South Texas Project  
Units 1 & 2  
Docket Nos. STN 50-498, STN 50-499  
Submittal of Additional Information

Enclosed please find Houston Lighting and Power's (HL&P) responses to your recent Request for Additional Information (see reference). In the reference, the NRC forwarded PSB questions (430.106-136) and RSB questions (440.14-72). In Attachments 1 and 2 we have provided responses or anticipated response dates for all questions except 430.117, 430.120, 430.124, 430.126, 440.30, 440.38 and 440.39. Answers for these questions will be provided in future transmittals as they become available. For your information, marked-up FSAR sections are provided with the responses where appropriate.

Response to Request for  
Additional Information  
for the Power Systems Branch (PSB)

RHR COOLDOWN, 2 TRAINS OPERABLE  
AND ONE TRAIN OPERABLE  
FIGURE 5.4-9

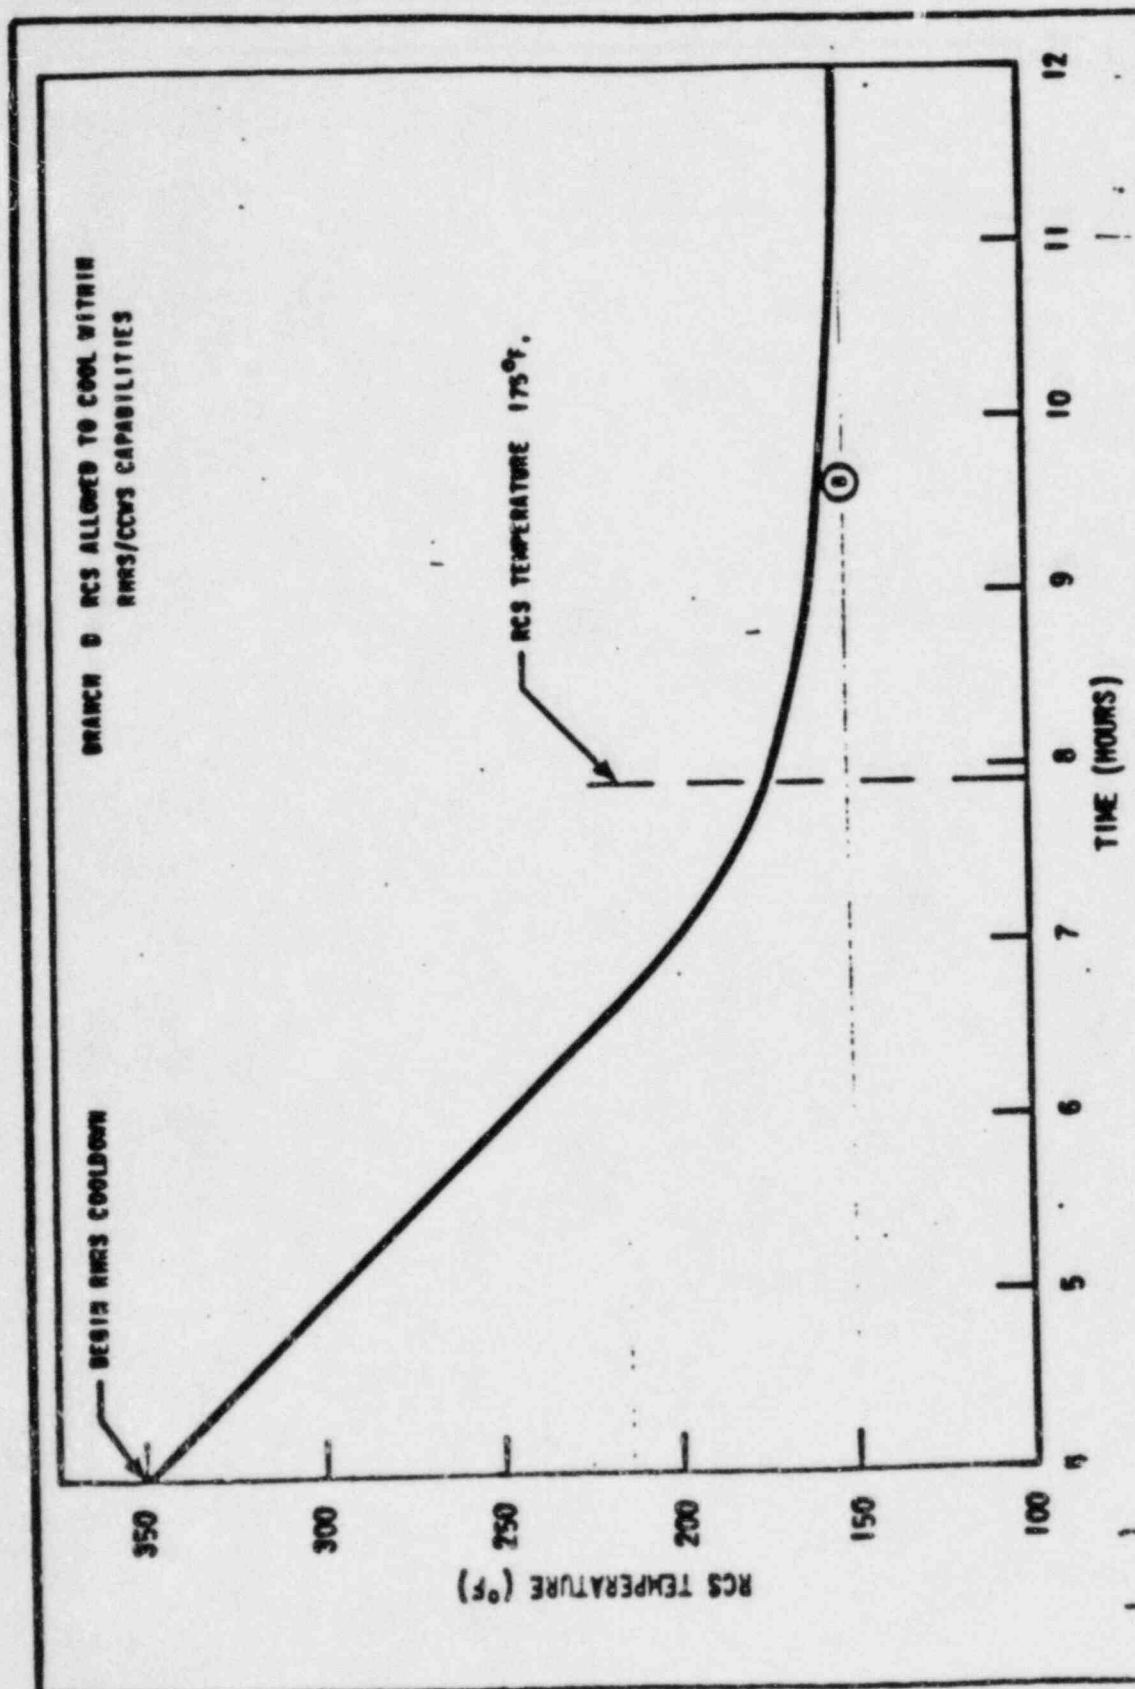
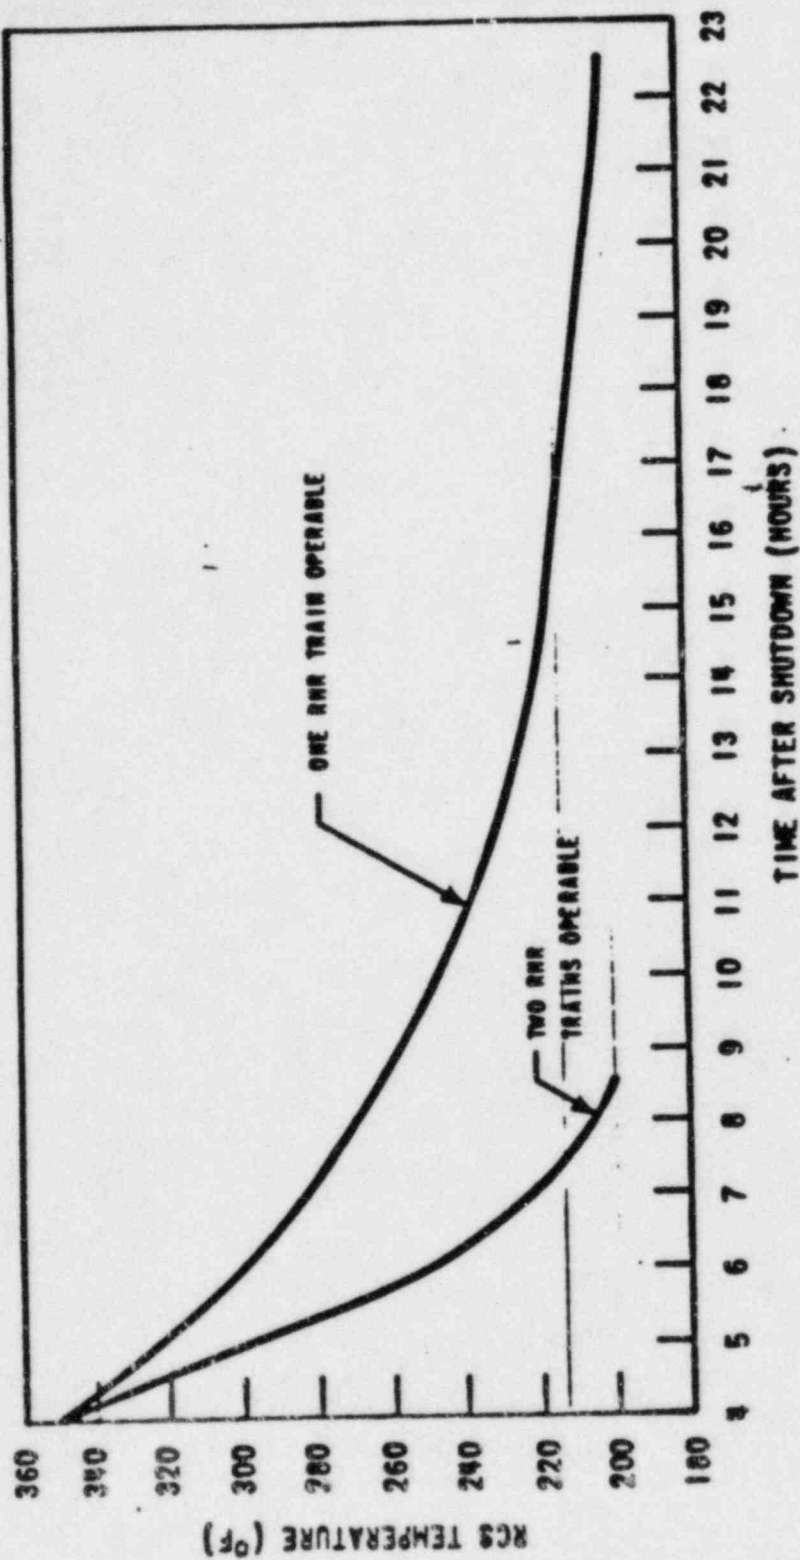
Explain the differences between the RHR cooldown rates listed in the text and those shown in Figures 5.4-8 and 5.4-9 (Amendment 38). As example, the time for 3 train cooldown from 350°F to 150°F is given as 8 hours in the text and shown as 12 hours in Figure 5.4-8. The time for 2 train cooldown from 350°F to 200°F is given as 5 hours in the text and shown as 8.5 hours in Figure 5.4-9.

The times required to cooldown the Reactor Coolant System using various configurations of the Residual Heat Removal System which are provided by Figures 5.4-8 and 5.4-9 of the South Texas Project FSAR are consistent with the calculated performance capabilities of the system. The FSAR text will be revised to be consistent with the figures.
